Product Change Notification

Date Issued :	October 25, 2022	PCN Number :	512647
Reason for Change :	Change to Product		
Description of Change :	The outer sleeve of the UltraLock head did not rotate freely. to ensure free rotation, the rear step of the inner sleeve was adjusted accordingly. The diameter was reduced and the step made longer.		
Reason for Short Notice :	Corrective Actions		
Assessment of Change :	First Article Inspection		
Planned Implementation Date :	November 25, 2022		
Sample Availability Date:	September 30, 2022		
Internal Molex Qualification Date :	September 30, 2022		
Last date to request Samples by Customer :	October 14, 2022		
Traceability Code Markings / Date :	No special marking on the product or packaging

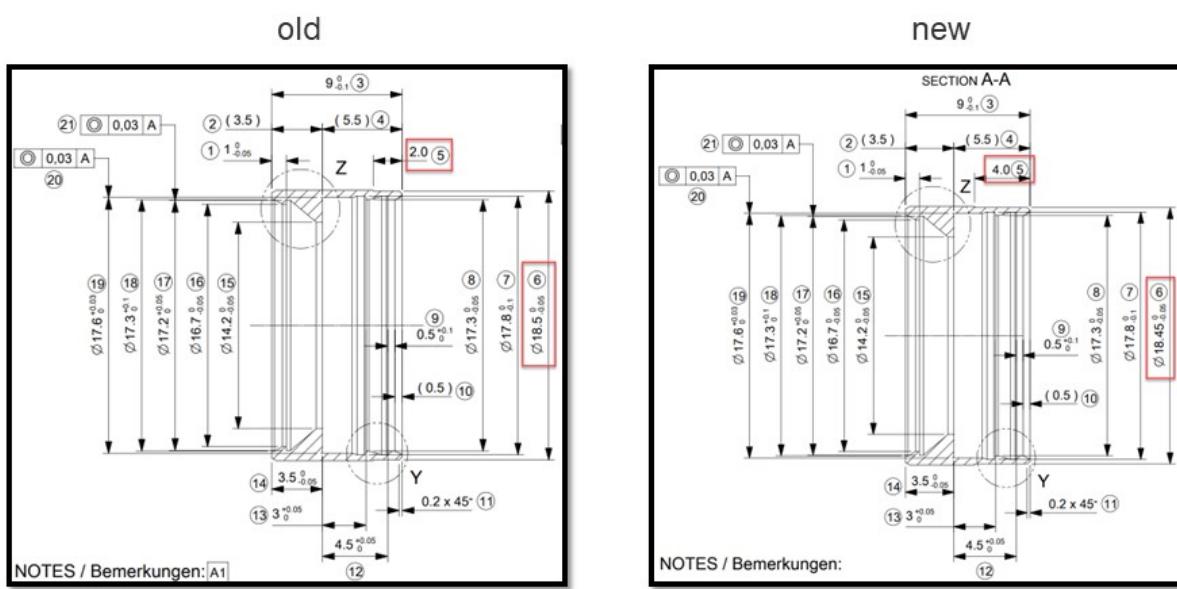
- The outer sleeve of the UltraLock head did not rotate freely. To ensure free rotation, the rear shoulder of the inner sleeve was adjusted accordingly. The diameter was reduced and the step made longer.
- Product Impact
 - No impact for function
- Part Number Impact
 - 1203070246
